Rossett Road (B5102), Wrexham Section 278 Highway Works Review of Eddisons Design Drawings

Table of Drawings and Review Comments

Table2 – List of Comments on Drawings

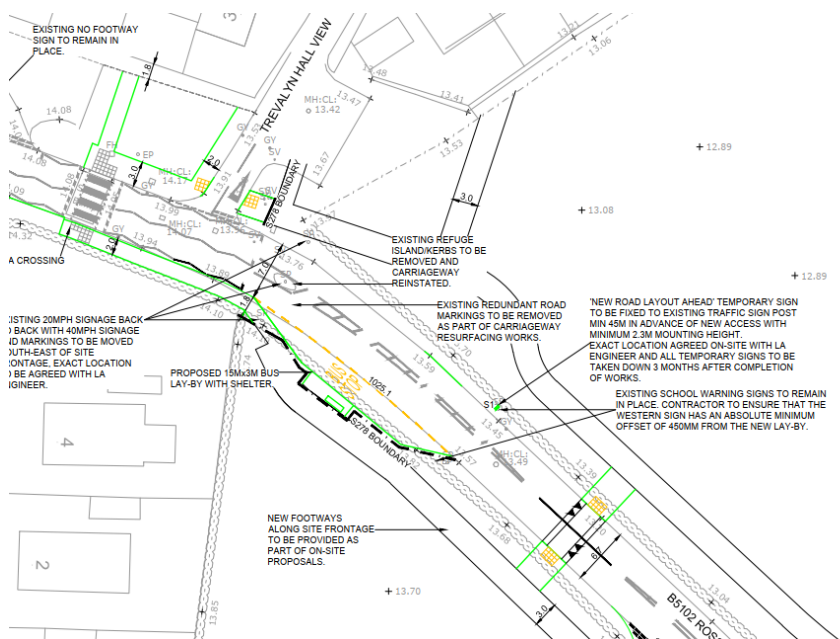
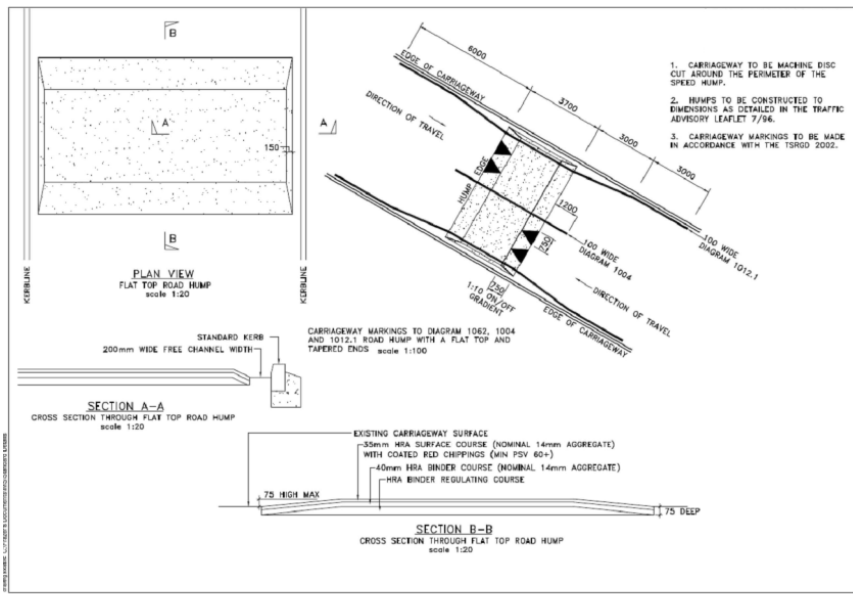
Ref	Dwg Ref. 3261-****	Extract from Dwg and Google Street View	Comment	Suggestion	Designers Response
1	D001 revK	 Views on approach to site from Trevalyn (2011) View approx. 500m from site  View approx. 80m from site 	Speeding / Gateway Feature (circled red) The introduction of traffic calming speed cushions is welcome. The gateway feature shown which comprises speed limit warning sign and roadmarkings could and should be more robust and therefore more effective in our view. This could take the form of a double speed cushion or priority gateway feature. However we understand from discussions / meetings with CCBC/MM/Eddisons/CastleGreenHomes that WCBC are willing to accept a design without gateway humps or priority traffic calming feature. Location of Road Hump Warning Sign (circled purple) The sign is current estimated to be between 5 to 10m in advance of the first pair of cushions, circled in purple opposite. The traffic signs manual (TSM) Chapter 4 Appendix A advises a “minimum clear visibility distance” to the sign of 60m and “a distance (of sign) from hazard” of 45-110m. Also noting dwg D003, the sign and plate including bilingual text have been placed on one sign face and yellow backed on both sides of the road. This creates a high-profile feature which we would argue risks detracting from the actual gateway feature and change in speed limit. We would likely prefer the emphasis given to the actual gateway feature and change of speed limit and place one standard road hump warning sign in advance of the gateway feature which is also more in line with the TSM advice. Speed Limit Advanced Warning Sign (circled yellow) See comment Dwg D003	Locate the sign/s in accordance with the TSM including practical consideration of the bend. Typically we have placed the highway features in the following order “ARAF/SLOW” roadmarking, road hump warning sign, gateway feature including speed limit signs then hazard (cushions).	Comments noted. Signs now relocated in accordance with TSM and highway features now proposed in the preferred order.

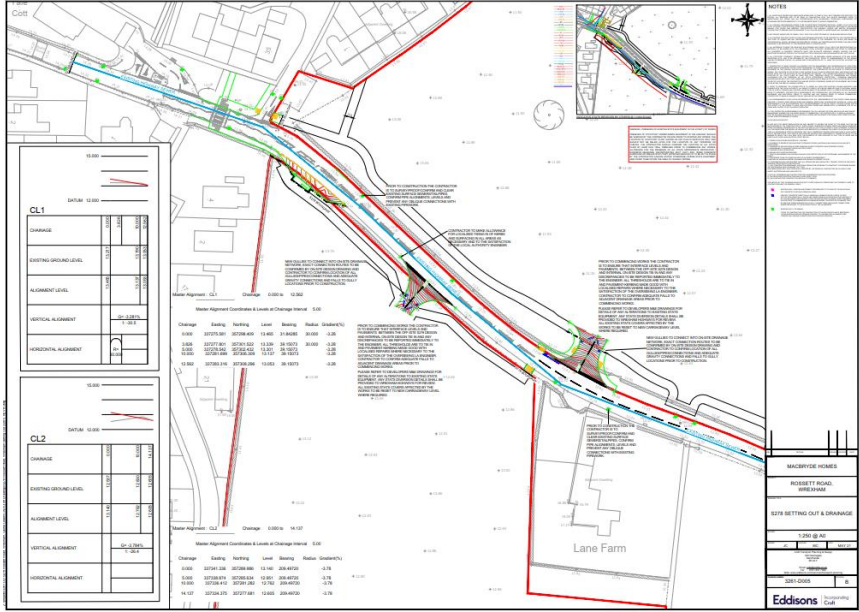
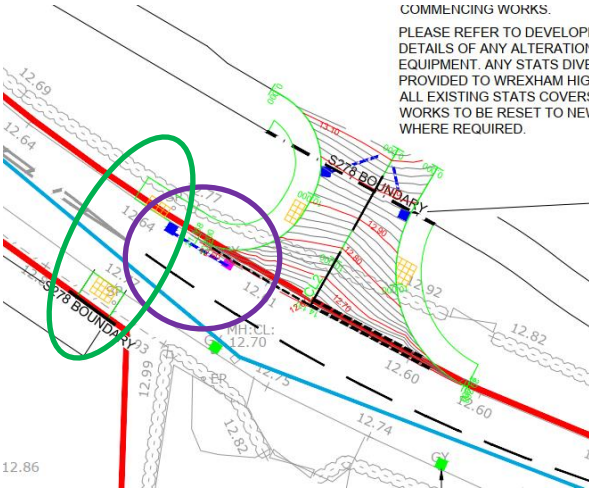
2	D001 revK		Wheelchair Users accessing Holt Road (circled red) Even with the proposed traffic calming the risks of anticipating that wheelchair users will travel on a live road for even approximately 20m is not acceptable. We do not believe this arrangement will pass a Road Safety Audit assessment. If it is the ambition of WCBC to provide access for users along this section of Holt Road we recommend alternative layouts are considered.	Consider alternative layouts to facilitate as safe a use as is reasonably possible of this section of the road. This might be by replacing the proposed speed cushion with an elongated build-out as part of a Priority Give-Way. However we understand from discussions / meetings with WCBC/Eddisons/CastleGreenHomes that WCBC are willing to accept the current proposal.	As stated, WCBC accept the current proposal following previous discussions.	
3	D001 revK	No revised lighting layout available	Lighting There are no proposed lighting columns shown on the drawings. This does not allow MM to make even a qualitative assessment of, for example, of whether there is adequate illumination at the proposed crossing, how columns will impact or assist signage and whether illuminated signs or required.	The drawing must show the proposed lighting.	The S278 GA now shows the proposed street lighting.

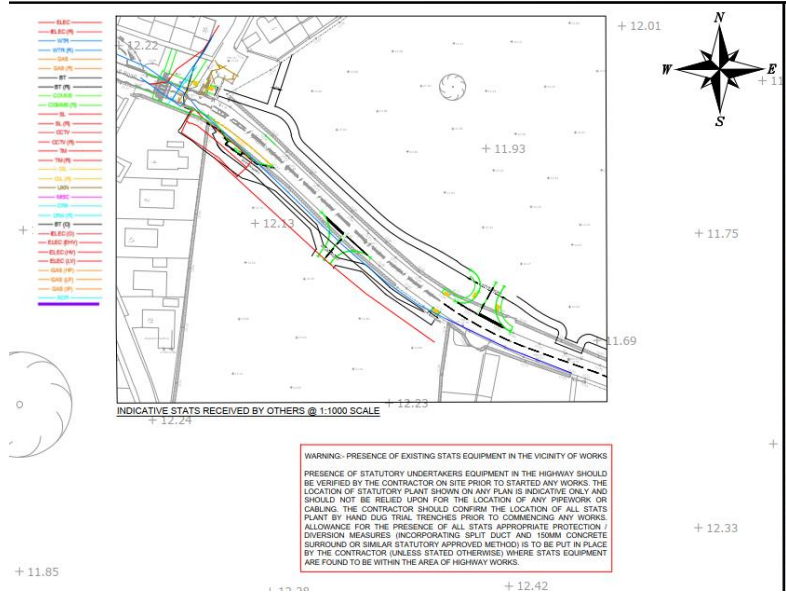
4	D001 revK		Pedestrian Crossing (circled blue) Visibility The extent of hedge removal and replacement with “new tree/landscaping in line with on-site drawings” is not clear. The extent of removal should be sufficient to allow adequate visibility for users of the crossing. Detail See comments on dwg D004 but essentially there are no details for this feature	Confirm extent of removal of hedge on drawing. Provide specific detail for this feature.	The visibility splays to the new crossing point are now illustrated on the plan with notes referring to extents of hedge removal/trimming back. A detail for this feature is now included on the latest revision of D004.

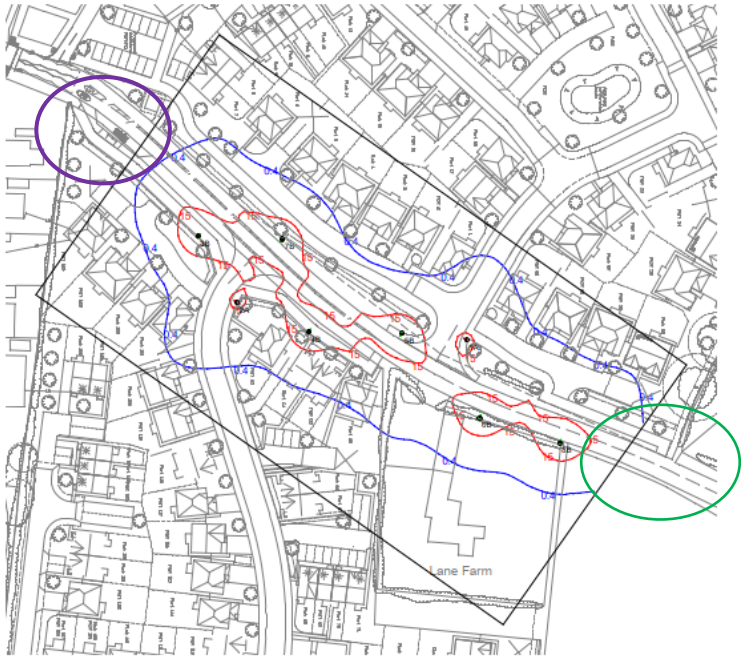
6	D003 revJ		Signage Advance Warning Sign 20mph (circled green) The width and height of the sign face would lead us to understand that the 20mph part of the sign is 300dia. - typically used for repeater signs. If this sign is necessary at all, the speed limit should be 600dia. Yellow backing Yellow backing to three signs is proposed. Our view is that, if yellow backing is to be used, it should be restricted to the gateway feature to highlight its presence. Using it at three locations will diminish the prominence of the terminal speed limit sign at the gateway. Road hump sign (circled blue) For comments on location see ref 1 above. 20mph terminal sign (circled purple) The proposal is for a standard sign whereas it could be made as noticeable but in a more unique and noticeable way, see example opposite. 40mph sign (circled yellow) Consider reuse of existing signs from existing gateway feature. Because there are no lighting columns shown on the drawings it is not possible to comment on whether signs should be illuminated or not.	Consider if sign is necessary. If required increase size to 600dia. Restrict the use of yellow backing to signage in gateway. Relocate sign Consider making sign more unique and thereby noticeable Consider reuse of existing sign Show lighting column locations.	Upon further review, the advance warning 20mph signs have been removed from the scheme as they are not a standard traffic sign. Yellow backing board now removed from other signs and gateway signage updated to match the existing gateway signage and propose a 20mph zone rather than just 20mph terminal speed limit signs. Road hump sign relocated. 20mph zone signs now proposed to match existing with additional text to make the sign unique to the location. 40mph signs now match the existing with notes on the plan to state that existing signs to potentially be re-used in new location. Lighting column locations now shown.
